Appendix B: Supplement to HydroQuest December 5, 2022 report titled: *Proposed Terramor Glamping Project: Hydrologic and Land Use Based Justification for Issuance of a Positive SEQRA Declaration*

RE: Terramor Failed to Document Sufficient Water Supply Availability, Adverse Impact to Neighboring Homeowner Water Supplies, Wetland Impacts, and Potential Water Quality Degradation of Sacred Pond Waters Downstream of their Wastewater Discharge Location - A Negative SEQRA Declaration and/or a Public Hearing are NOT Warranted Because Significant Adverse Environmental Impacts are Clearly Demonstrated in the Limited Number of Homeowner Wells HydroQuest and Mid-Hudson Geosciences Were Able to Monitor During Terramor's Three Pumping Tests

Figure 22

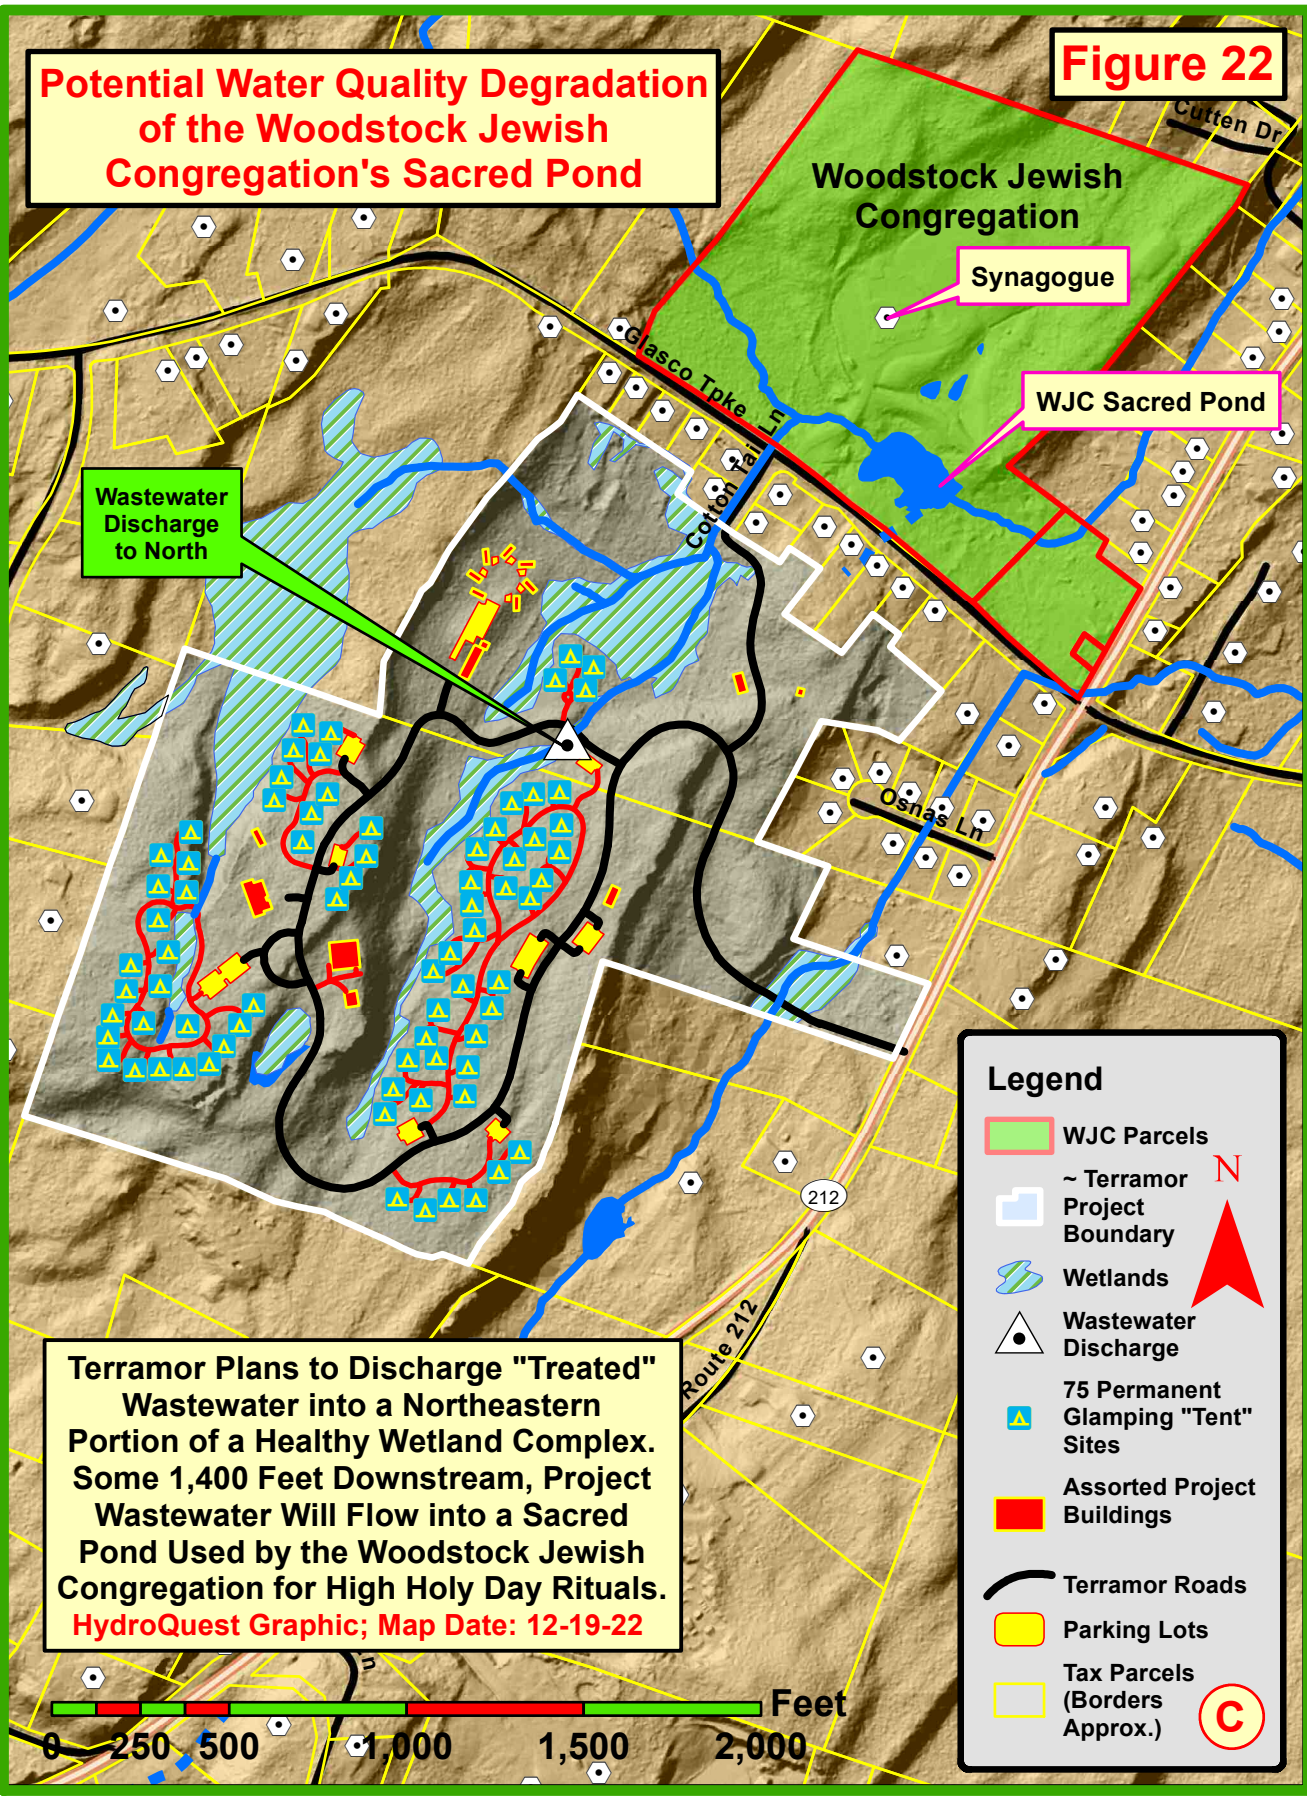
- Potential water quality degradation of the Woodstock Jewish Congregation's sacred pond, situated 1,400 feet downstream of Terramor's wastewater discharge location, requires comprehensive evaluation (Figure 22).

- Terramor plans to discharge “treated” wastewater into a northeastern portion of a healthy wetland complex. Some 1,400 feet downstream, project wastewater will flow into a sacred pond used by the Woodstock Jewish Congregation for high holy day rituals (Figure 22). This is unacceptable and therefore requires reevaluation.

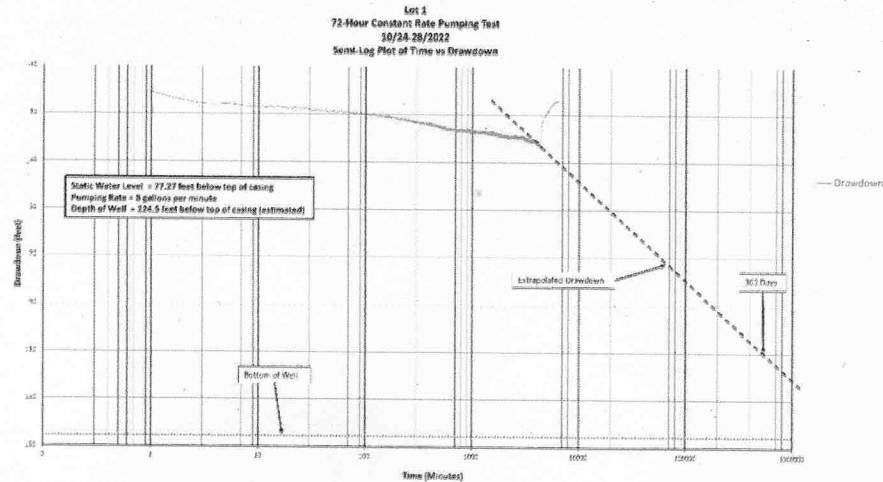
- Terramor's Exhibit F (well report) depicts three semilog plots of drawdown versus time. They are labeled "72-Hour Constant Rate Pumping Test." Yet, two of three plots have label boxes stating "Adjusted Rate." The Lot 23 pumping test graph, for example, shows a major change in drawdown slope associated with the adjusted flow rate. While a text box on the graph states the pumping rate was 4 gallons per minute, the pumping rate was not kept constant as specified in Part 5, Subpart 5-1 of the State Sanitary Code, Appendix 5B (Section 5-B.4). Driscoll (1986, Groundwater and Wells; the industry standard) recommends constant rate pumping tests with one or more observation wells so that key aquifer values can be calculated. HydroQuest emphasized the need to conduct aquifer testing with constant discharge rates in a letter dated October 4, 2022. No data is provided to explain important test particulars. Terramor provides no flow measurements and times, nor water level data charts, to evaluate testing conditions. Importantly, hydrogeologists conducting pumping tests seek to maintain a constant pumping rate to allow accurate aquifer characterization. Terramor did not follow this standard industry practice;

- Terramor shows three semilog drawdown versus time graphs. They provide no data nor graphs to show aquifer recovery as is specified in Part 5, Subpart 5-1 of the State Sanitary Code, Appendix 5B (Section 5-B.4). Recovery and whether water levels return to static levels is critical information used in assessing potential long-term aquifer performance (i.e., the aquifer’s ability to meet project demand over time). HydroQuest and Mid-Hudson Geosciences’ Figures 19 and 21 show multi-day aquifer recovery times in homeowner wells following Terramor’s pumping tests. **Based on the Terramor well report submitted to the Planning Board in support of a negative SEQRA declaration, we recommend that either new aquifer testing be conducted, all project advancement be placed on hold until aquifer testing is comprehensively conducted, or the project application be dismissed;**
